Agenda Item: Fullwood Station Administrative Amendment

DATE: April 5, 2016
FROM: Mary Jo Gollnitz

RE: Fullwood Station – Administrative Amendment

**FULLWOOD STATION
 SINGLE-FAMILY SUBDIVISION**
 PROVIDENT LAND SERVICES, INC. | MATTHEWS, NC | MECKLENBURG COUNTY
OVERALL GRADING PLAN

4563 "E" CONCEPT

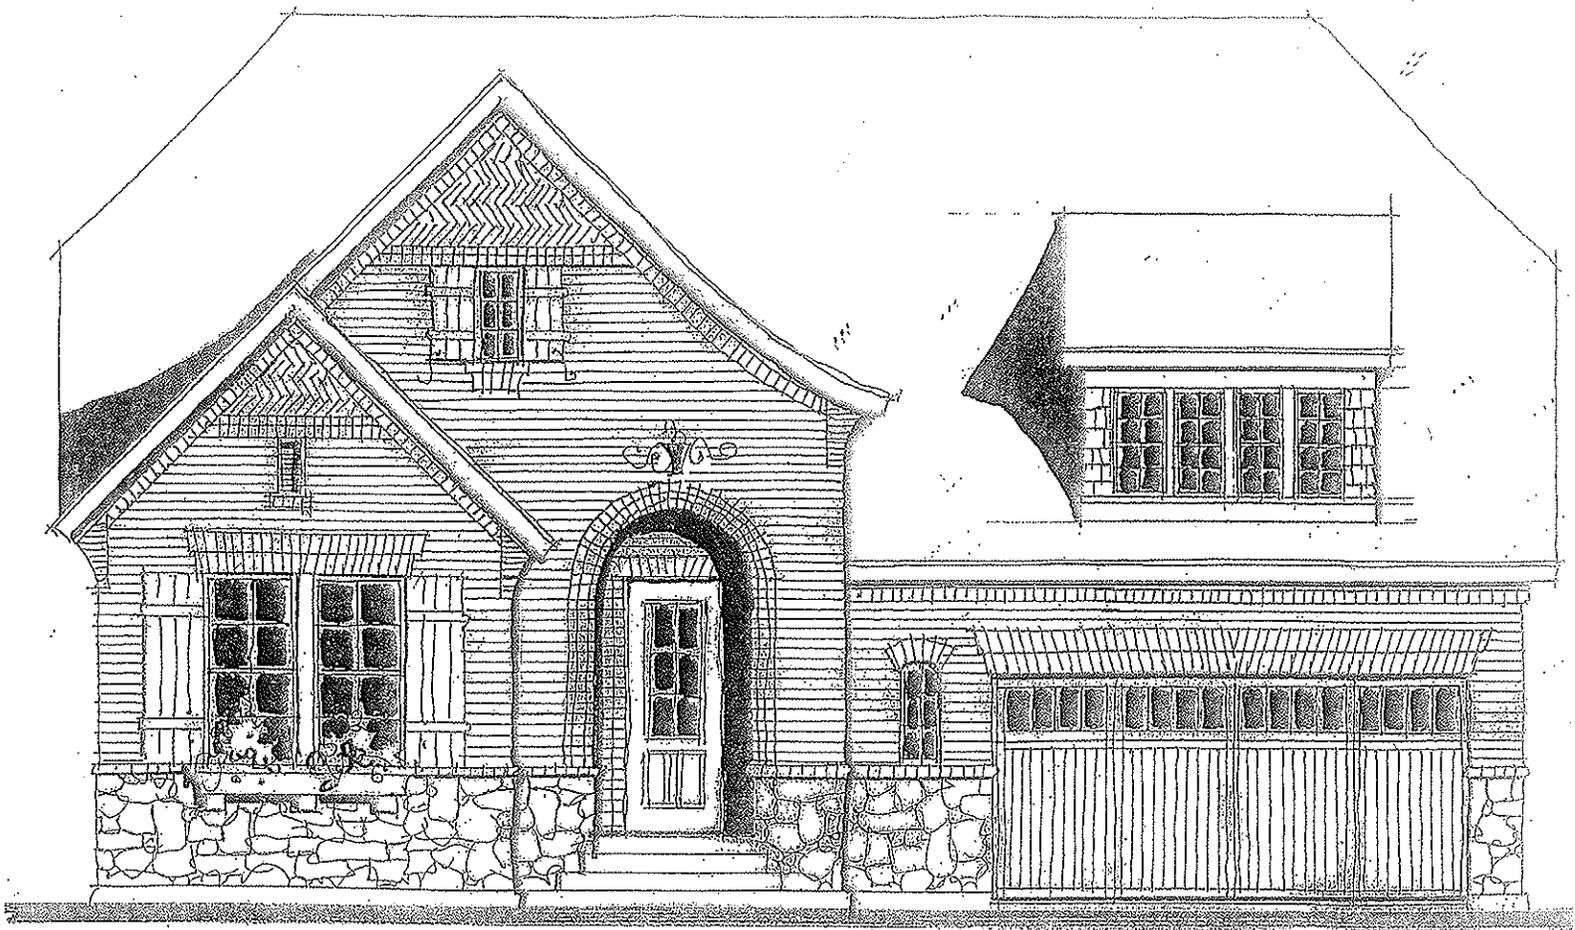
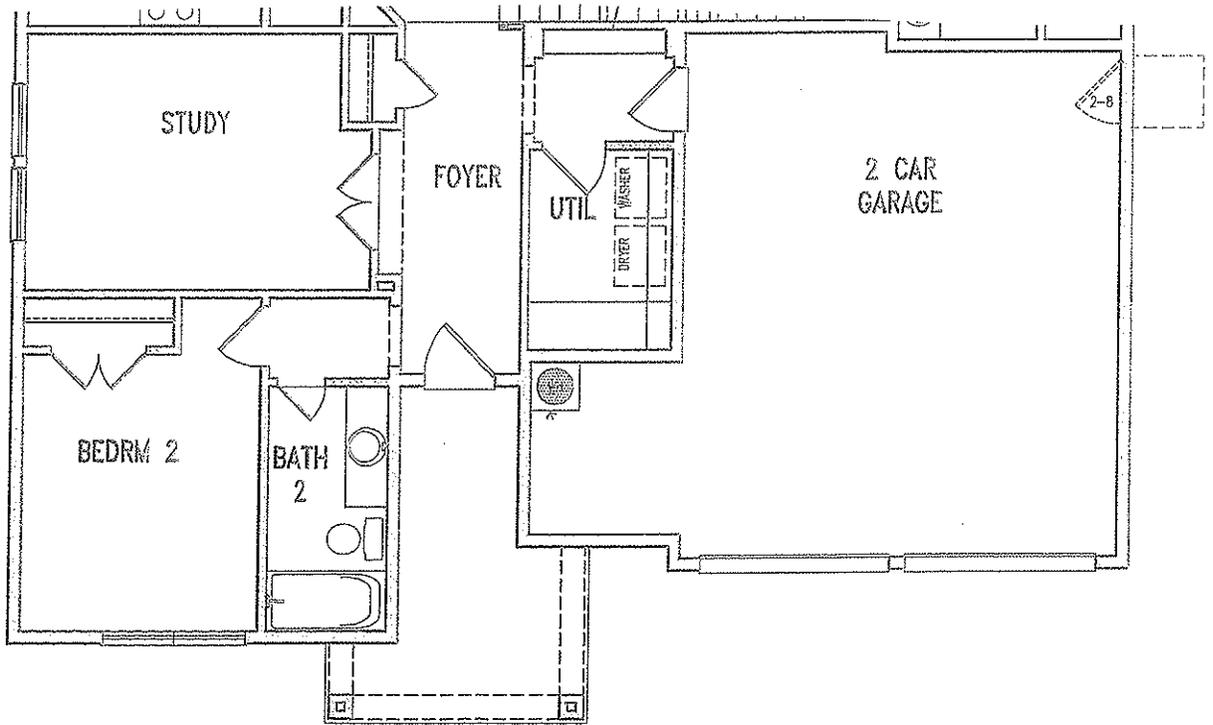
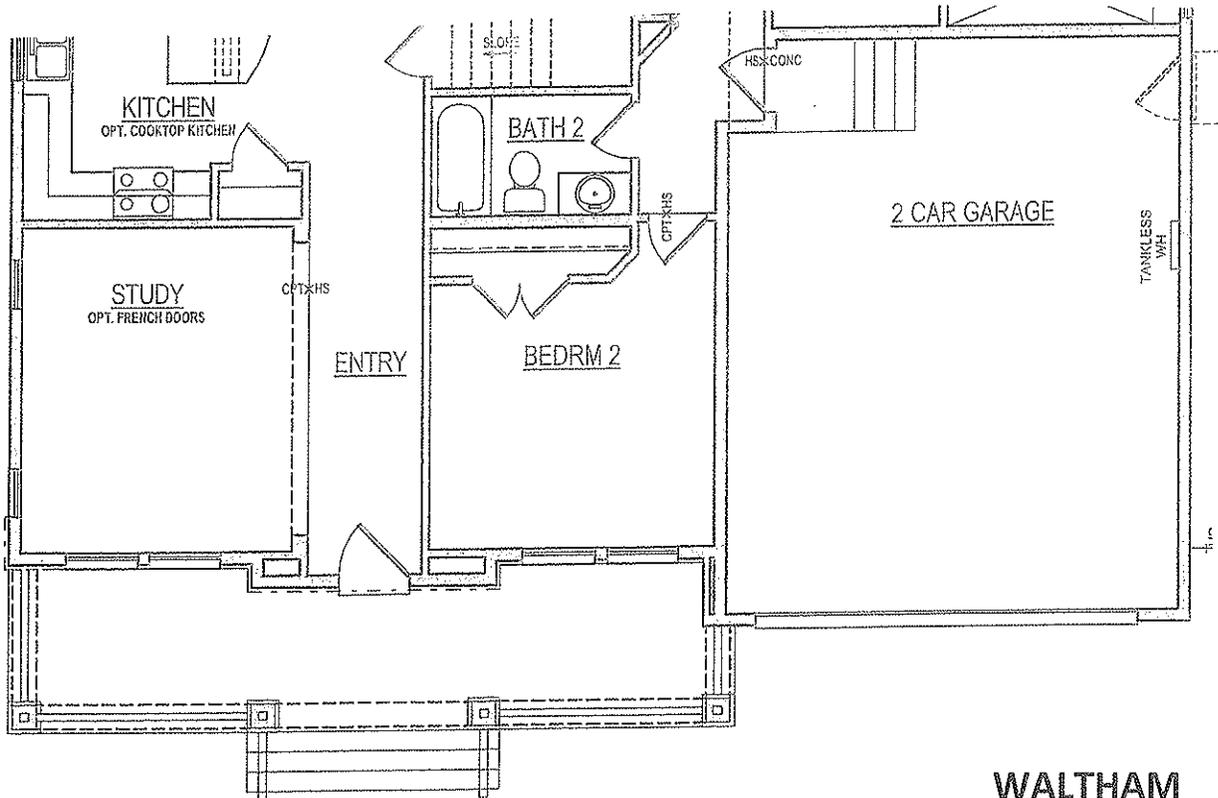
- A 6' sidewalk connection *“with steps out to S Trade St”* between Lots 5 and 6.
- Replacing previous house elevation illustrations due to a change in home builder.

6. Request to replace previous home renderings with new representative elevations provided by a new builder.

- 1 Provided house elevations make it difficult to determine if they all have four sided architecture agreed upon during the rezoning.
- 2 The trail terminus is positioned toward Woody Creek in order to provide a possible future connection to the greenway. Per the March 14 meeting discussion, the developer will provide \$2,940 funding for future connection. Price is based on 6' by 140' concrete path at current concrete pricing of \$3.50per square foot.
